Charlotte Historic District Commission Application for a Certificate of Appropriateness

April 13, 2011

ADDRESS OF PROPERTY	1333 Carlton Avenue, Dilworth Local Historic District	HDC 2011-038
SUMMARY OF REQUEST	Partial Front Porch Enclosure	
OWNER	William Patrick Burgess	
APPLICANT	William Patrick Burgess

② PORCH SECTION
1/4" = 70

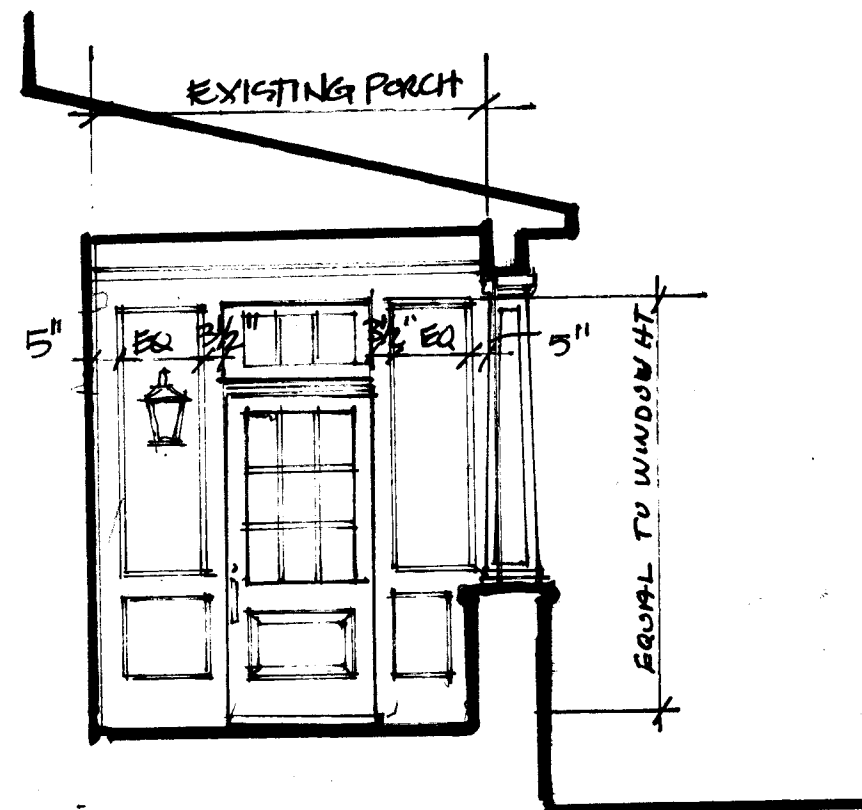
This proposal would create a sunroom from the right bay of the façade of this house, as shown on the attached plans.

The exterior walls of the enclosure would primarily consist of window units identical to those used when the house was constructed twelve years ago. The detailing and materials are also consistent with the existing house.

The Commission will have to determine the extent to which to apply this policy to a relatively recent infill structure.
